***Re: Responses to DEP & EPA December 2, 2008 Letter  
Former Framatome Facility  
Lots 1 & 2, 80 Wampus Lane, Milford, Connecticut***

# ***SUPPLEMENTAL INVESTIGATION WORK PLAN***

Former Framatome Facility  
Lots 1 & 2 - 80 Wampus Lane  
Milford, Connecticut

*Review of the  
supplemental investigation work plan  
for the Former Framatome Facility, Lots 1 & 2,  
80 Wampus Lane, Milford, Connecticut.*

**Figure 2 - Site Plan**  
Former Framatome Facility,  
Wampus Milford Associates,  
Milford, Connecticut

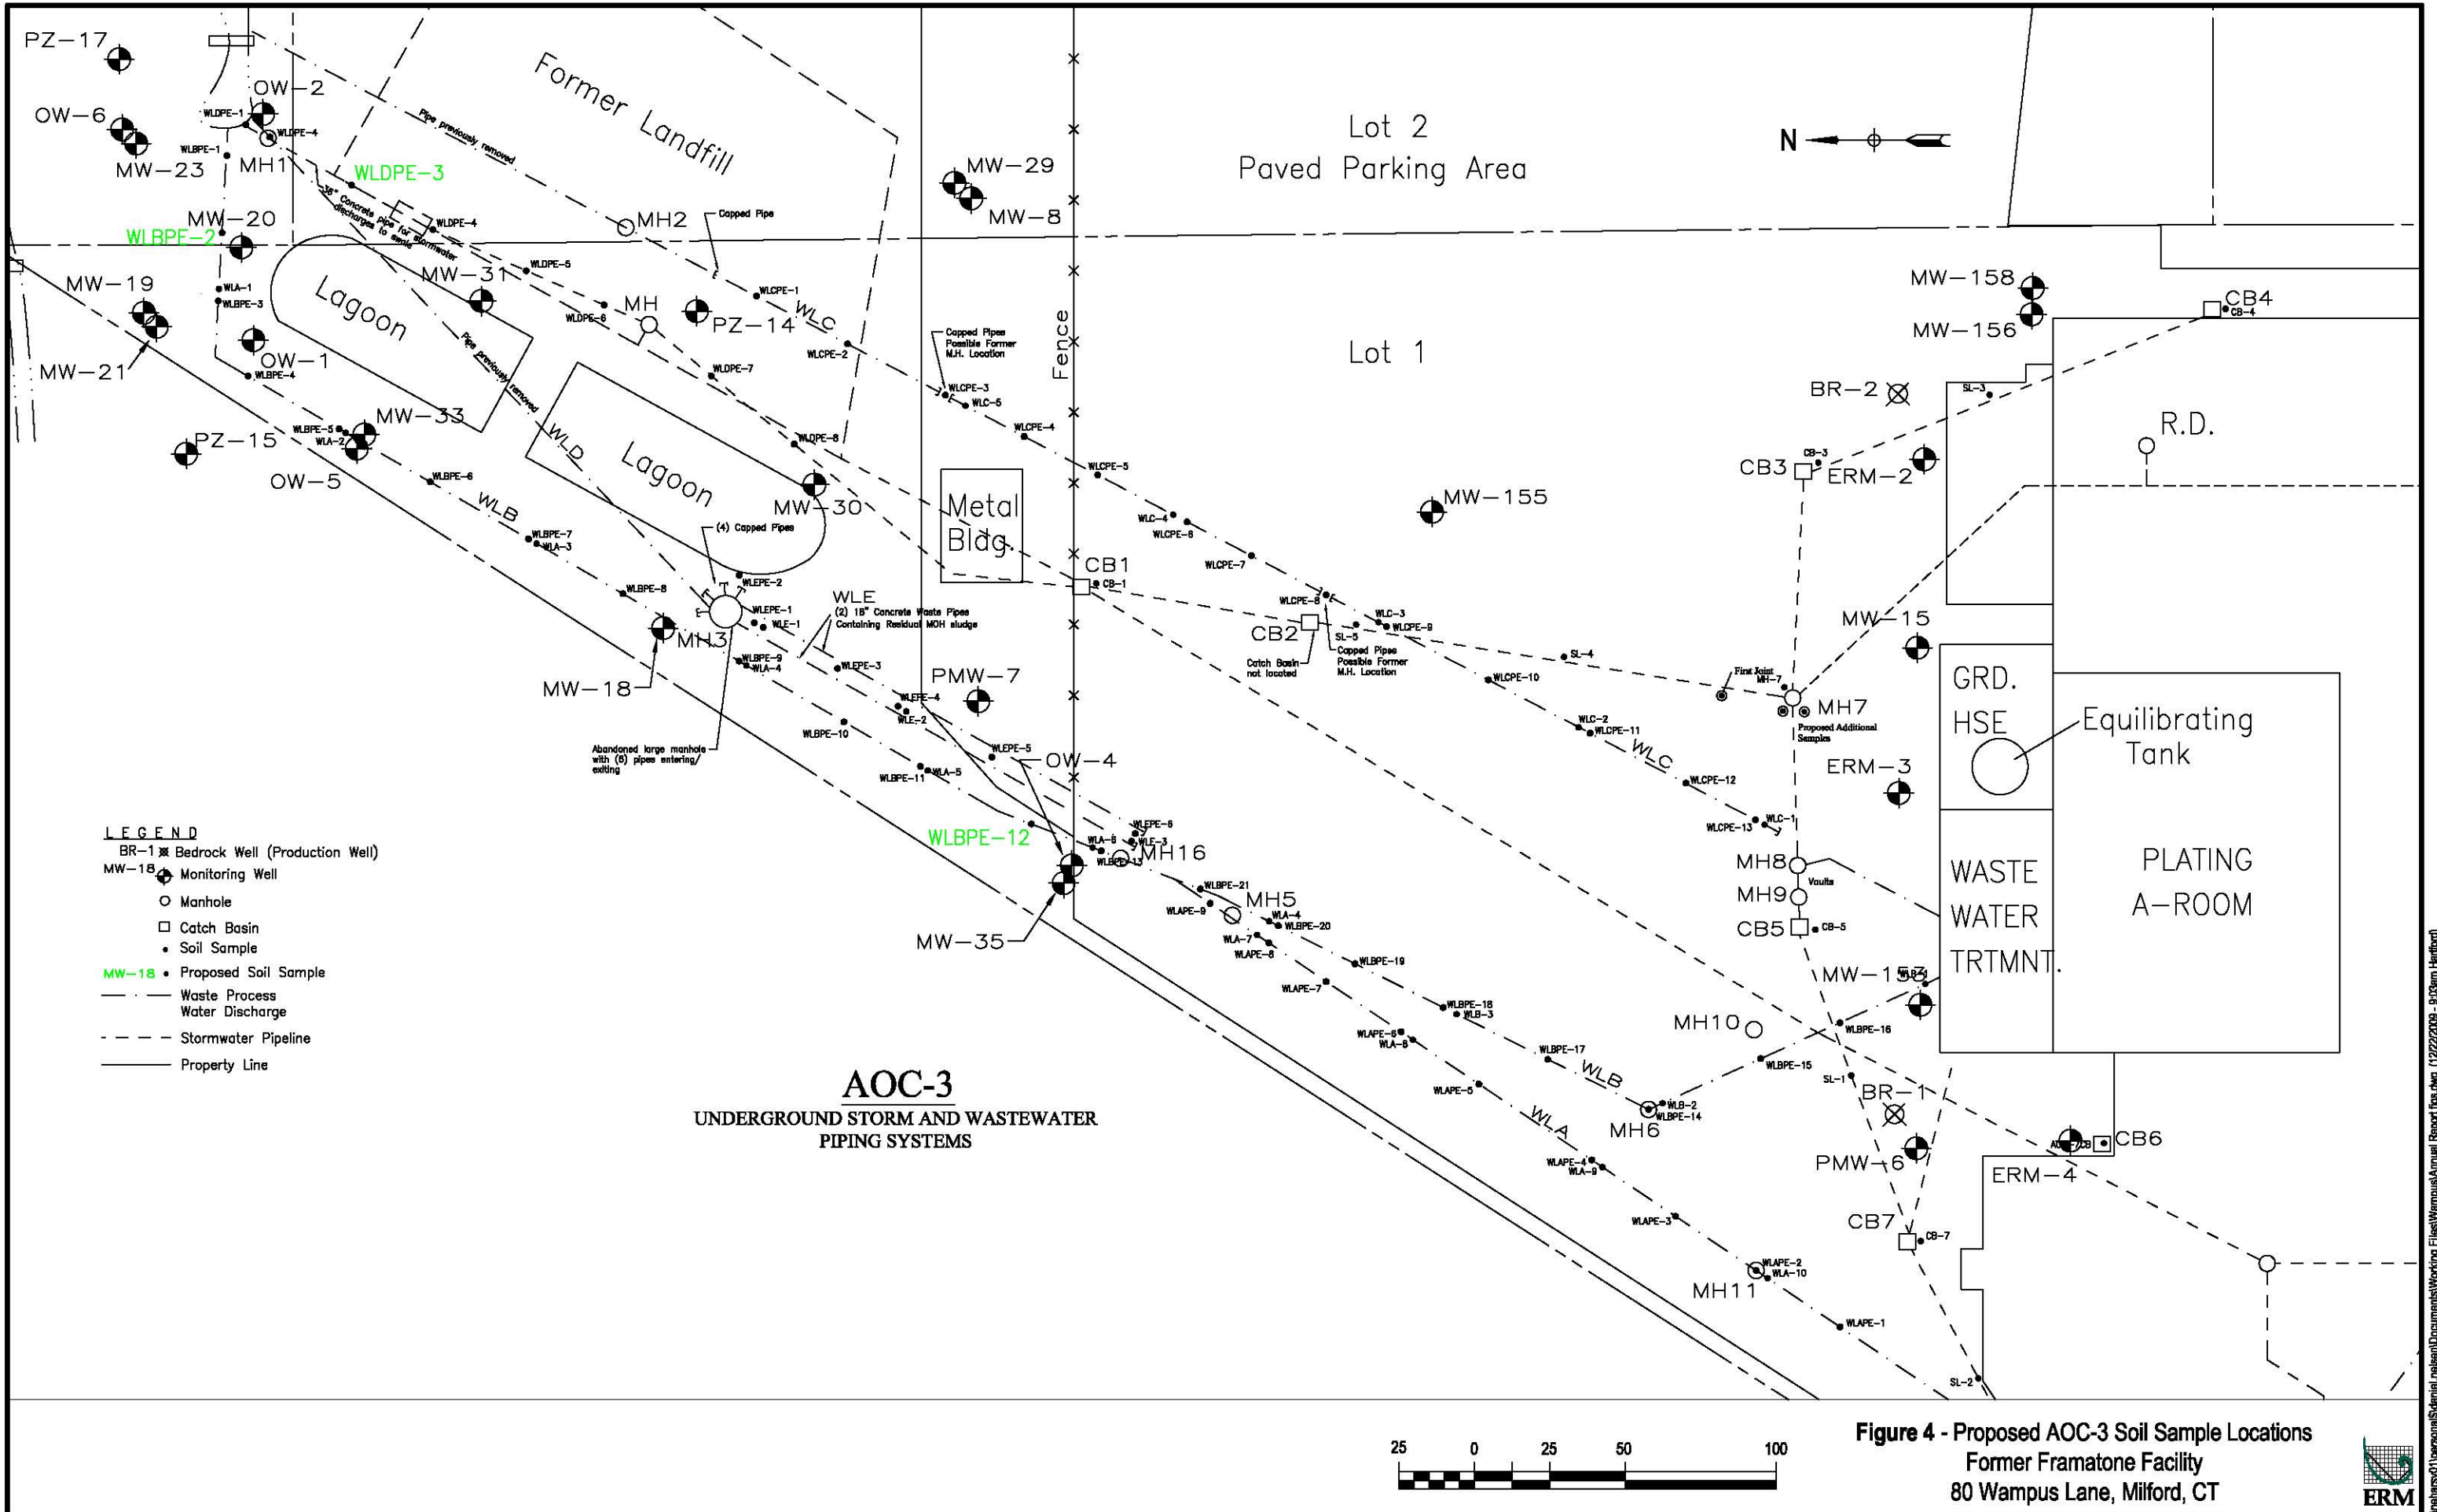
Figure 2 of the WP showed that the 2.47-acre parcel abuts Stubby Plain Brook (see shaded area). However, Figure 5 of the WP showed the same general area with nine wetland soil sampling locations in the “Marsh Area”. The text in the introduction about not addressing the parcel in the WP needs to be changed to reflect the proposed soil sampling program.

**Figure 5 - Sampling Locations**  
Stubby Plain Brook and Woodblock Area - Lot 1  
80 Wampus Lane, Milford, CT

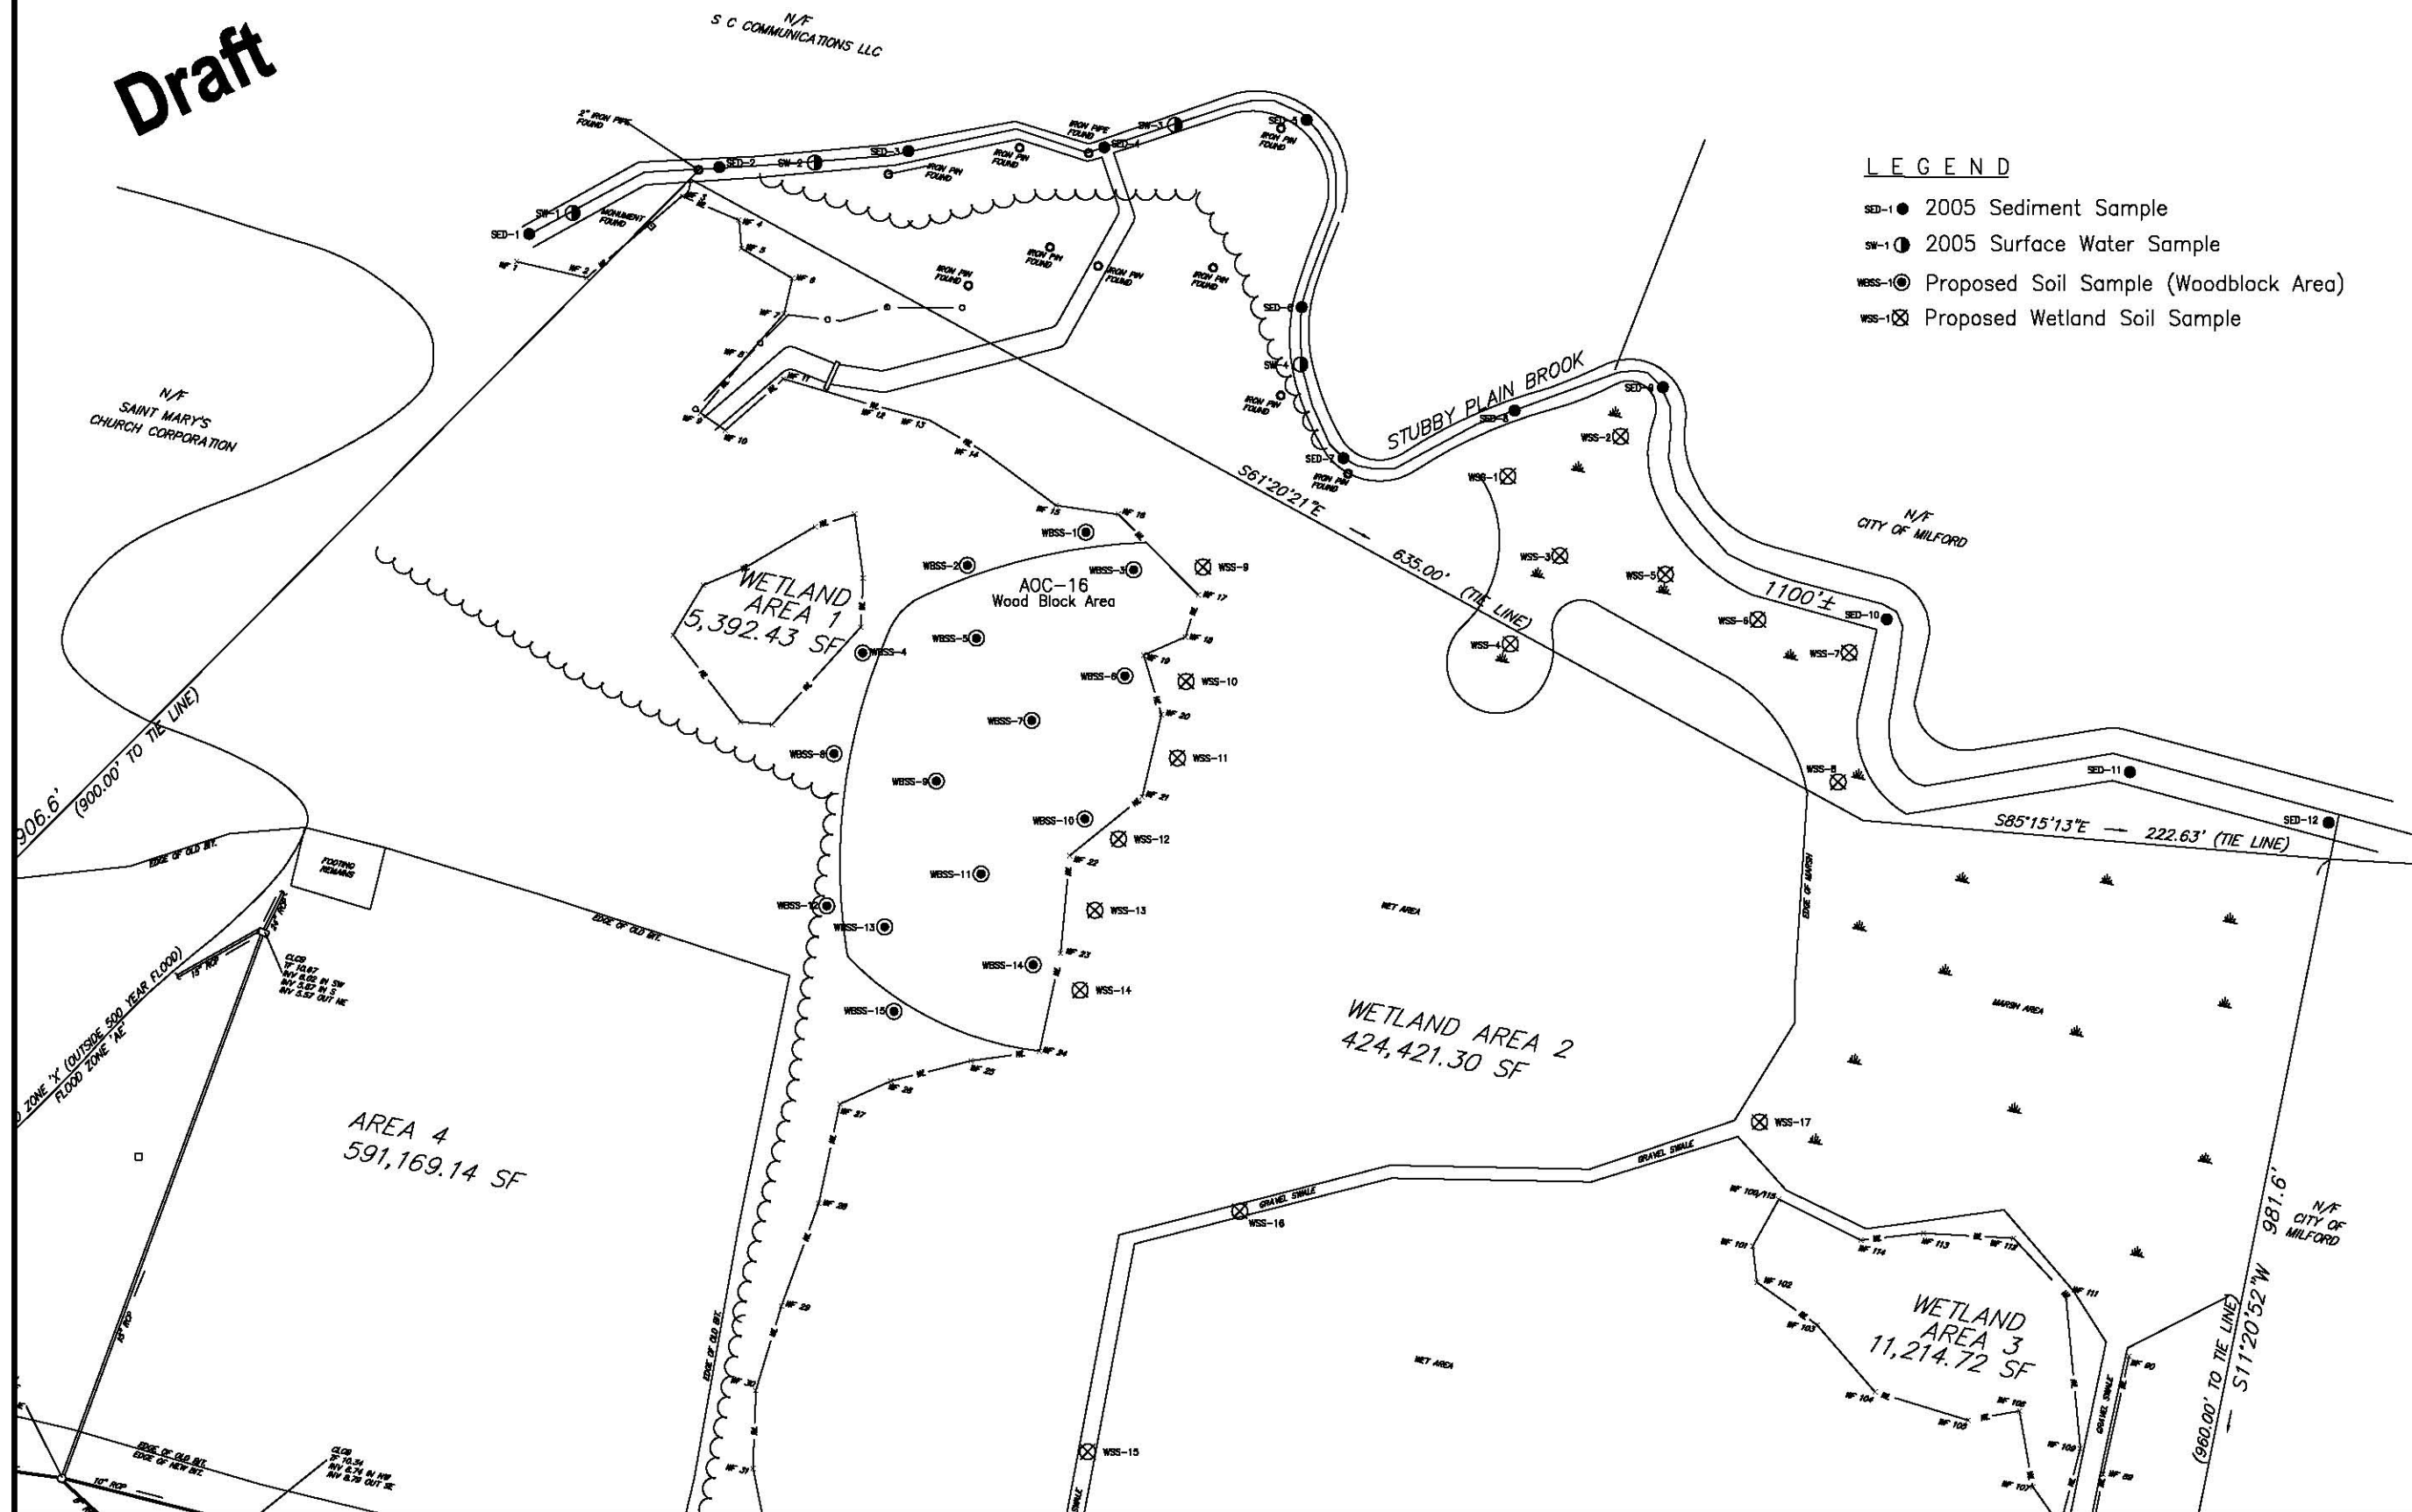
Figure 5 in the WP showed the proposed sampling locations for Area of Concern (AOC)-16 (the Wood Block Disposal Area) and Wetland Area 2. The legend in Figure 5, together with the text in §3.2.1 of the WP, only mentioned wetland "soils". It is unclear from the available information if Wetland Area 2, and the Marsh Area located downgradient from the gravel drainage swale (see Figure 5 in the WP), should also be considered as "sediment", at least for some periods during the year.

Neither Figure 5 nor the text in §3.2.1 of the WP discussed surface water sampling in the wetlands. As with the previous comment, it was unclear if the wetland areas are filled with surface water during part of the year, and should therefore be sampled for surface water analysis. It is recommended to provide more information on these habitats in order to resolve this potential data gap.

Figure 5 in the WP showed that six of the proposed soil sampling locations in Wetland Area 2 (specifically, WSS-9 to WSS-14) will be collected immediately east of AOC-16. The non-random distribution of these six samples suggested an attempt to determine if contamination from AOC-16 may have migrated into Wetland Area 2. If so, then the WP should specify that the proposed sampling locations next to AOC-16 were derived on that basis.

Figure 5 in the WP showed that eight more wetland soil samples (specifically, WSS-1 to WSS-8) will be collected from the Marsh Area next to a short stretch of Stubby Plain Brook at and north of the “Tie Line”. The WP did not explain why the wetland sampling effort was focused on that relatively small area next to the brook. Also, no soil samples (except for WSS-17 at the mouth of the gravel drainage swale) will be collected from the Marsh Area between the gravel drainage swale and Stubby Plain Brook further north. The text should fully explain and justify the distribution of the soil sampling locations in the Marsh Area.

This paragraph described collecting three soil samples from the gravel drainage swale (see Figure 5 in the WP). The swale descriptor suggested that a sample may have to be collected by first removing the overlying “gravel” before reaching the “soil” underneath it. Also, the sampling depth of 0-0.5 ft was different from the sampling depth for all other soil samples (i.e., 0-1 ft and 2-3 ft; see top two bullets on p. 11) to be collected elsewhere in the wetlands and the Wood Block Disposal Area. The proposed depth of 0-0.5 ft reflects more of a sediment sample instead of a soil sample. It is recommended to request more information on the sampling approach and to justify the sampling depth of the three gravel drainage swale samples.
